Newsom "A"

#9

SUNDRY NOTICES AND REPORTS ON WELLS

Attached to Form 9-331C
Supron Energy Corporation
Newsom "A" #7E
NW NE Sec. 10, T26N R8W
605' FNL & 1705' FEL
San Juan County, New Mexico

EXHIBIT "H"
Drill Rig Layout

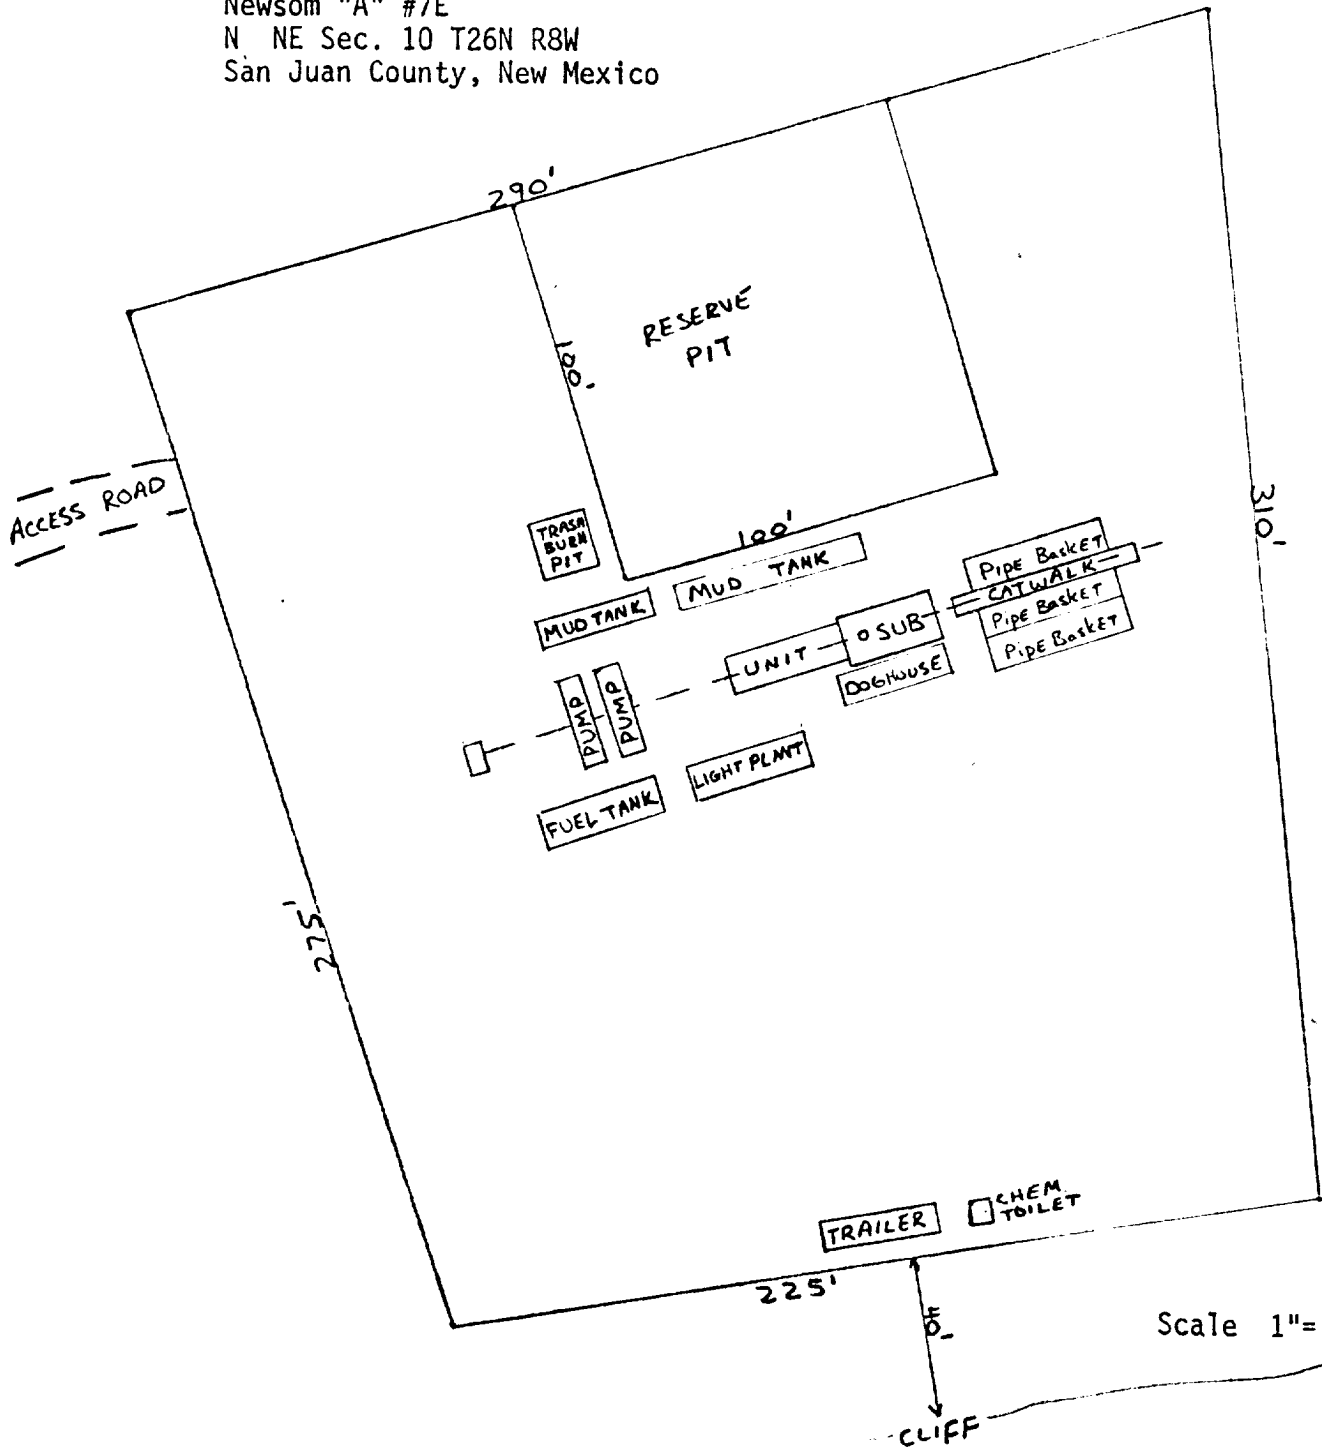
No additional surface disturbance is anticipated and the rig drilling to the Dakota will fit on the drill pad as approved. A Rig Layout is enclosed.
